Final Bridge and Channel Design Report

Sand Creek Drainageway Sterling Ranch Road and Briargate Parkway Branding Iron at Sterling Ranch Filing 2 Homestead at Sterling Ranch Filing 2

CDR 20-004
El Paso County, Colorado

Engineering Review

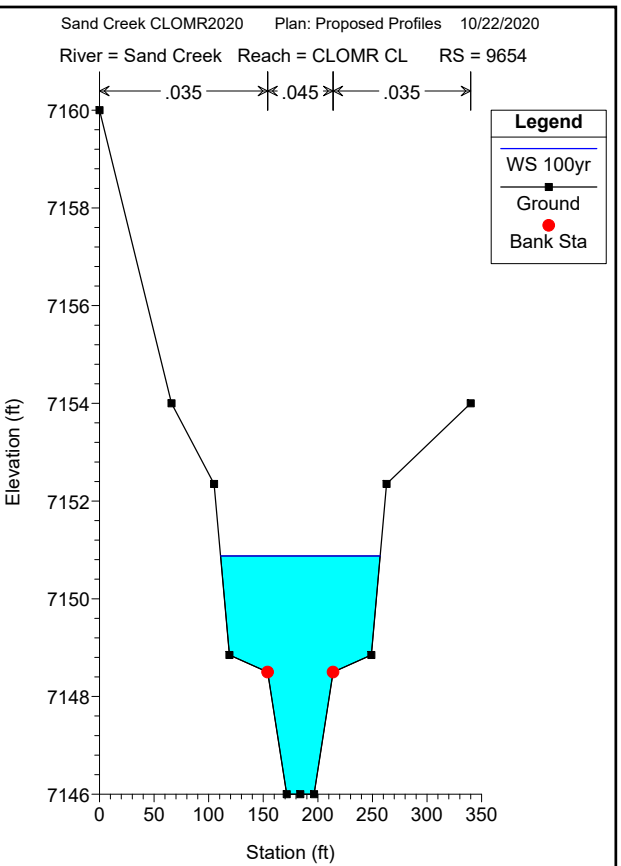
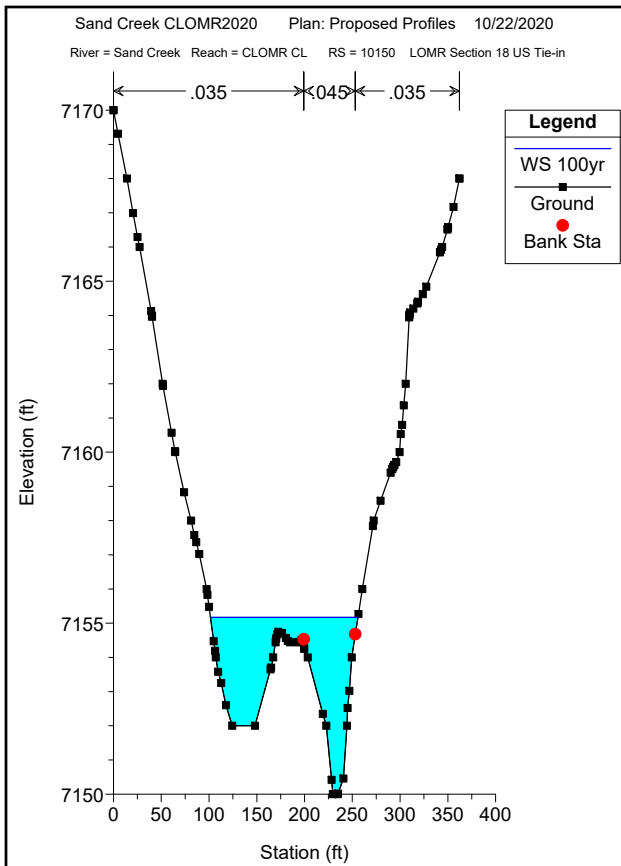
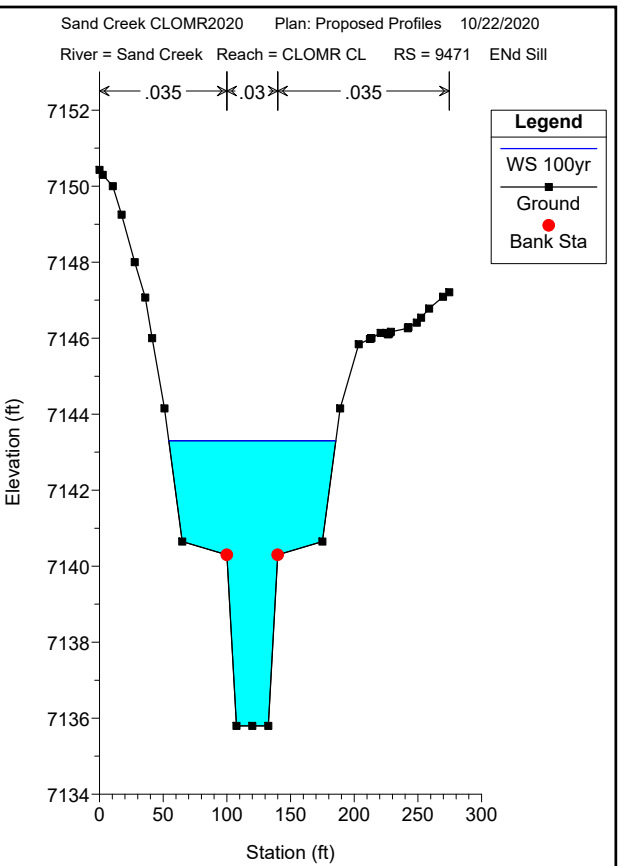
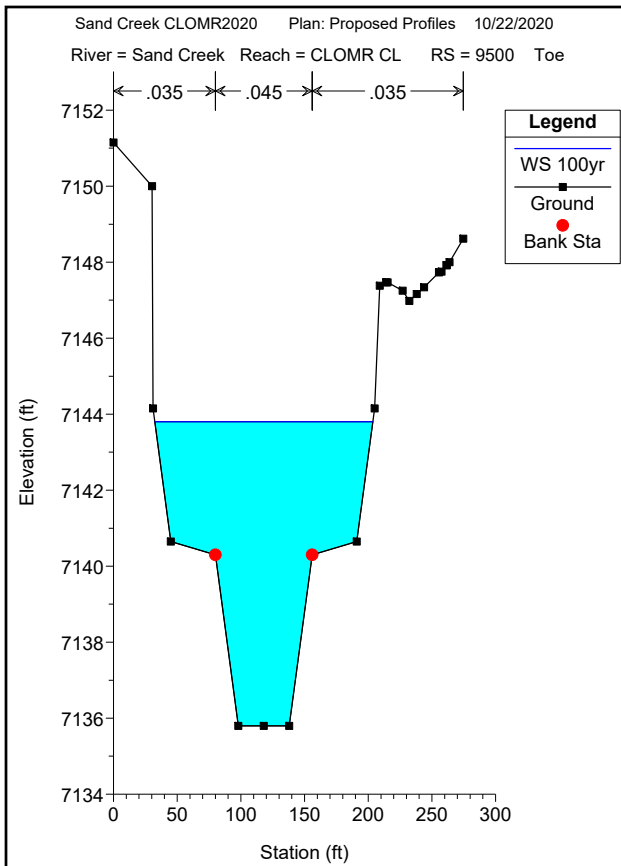
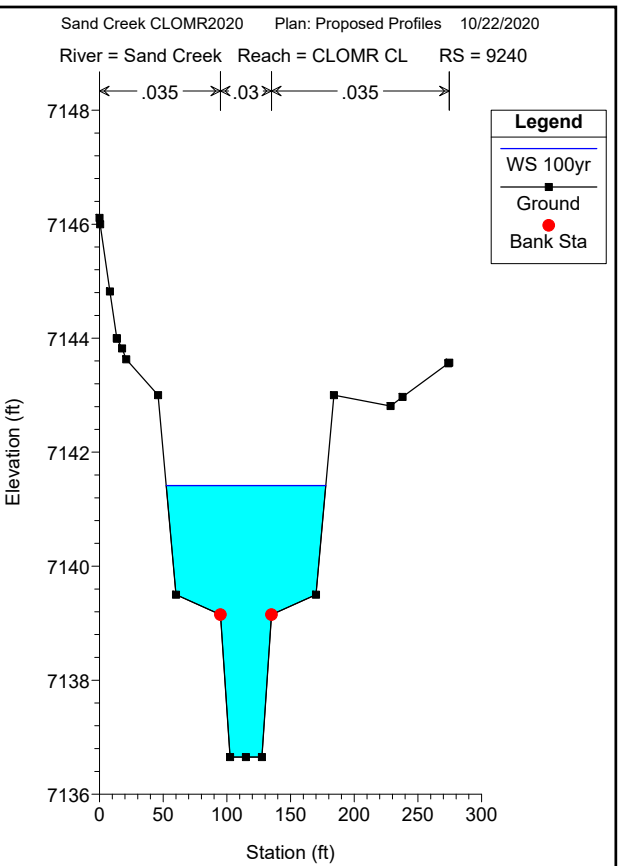
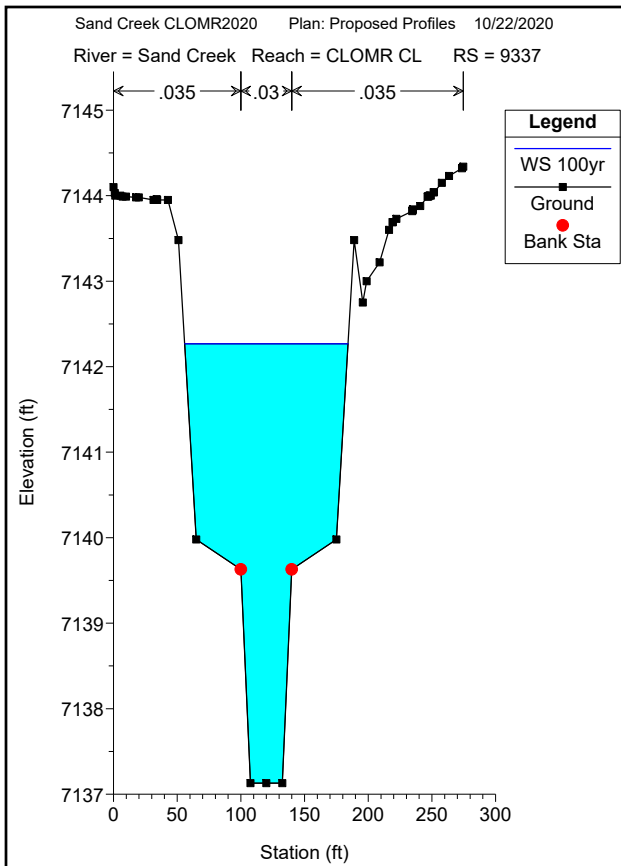
Provide modeling to DP 60A
(downstream of proposed pond outfall)

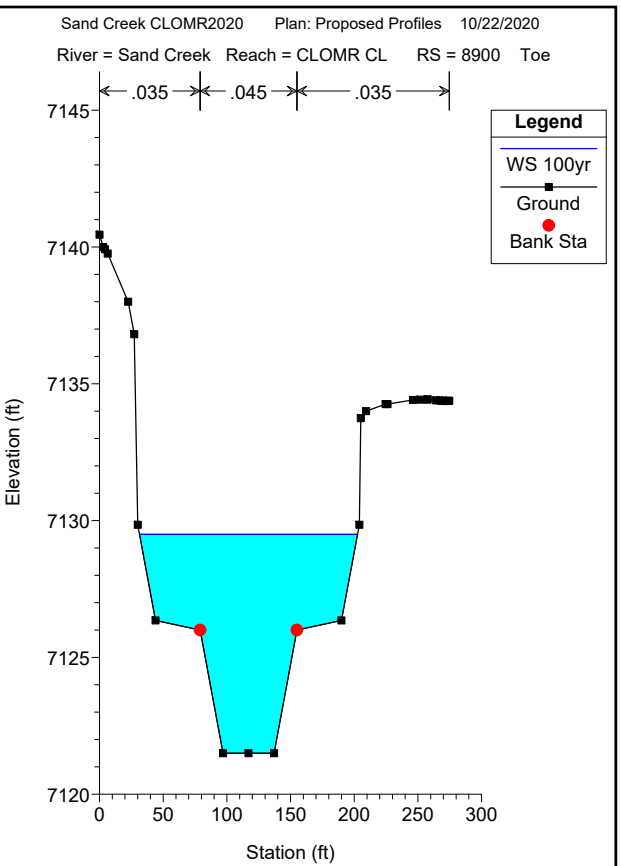
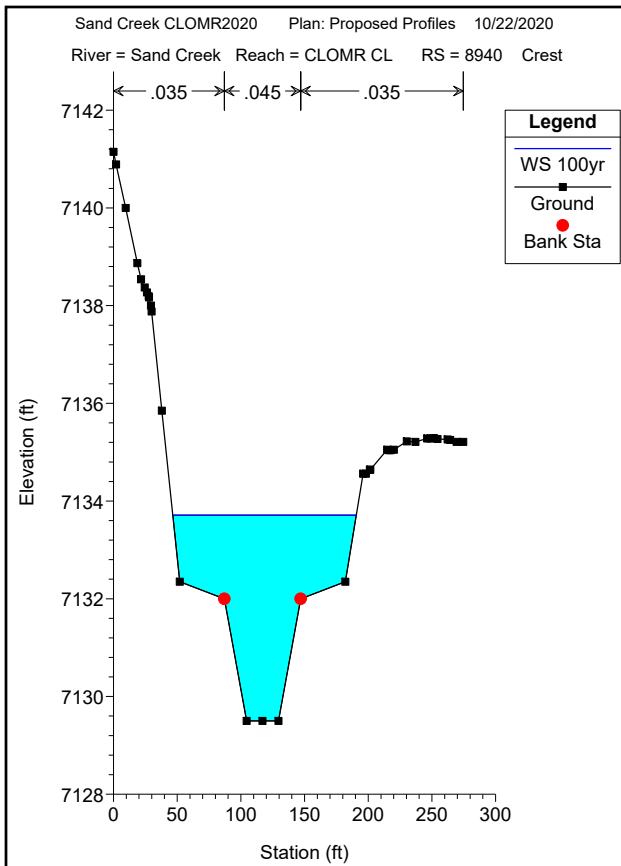
Excessive
velocities
highlighted.
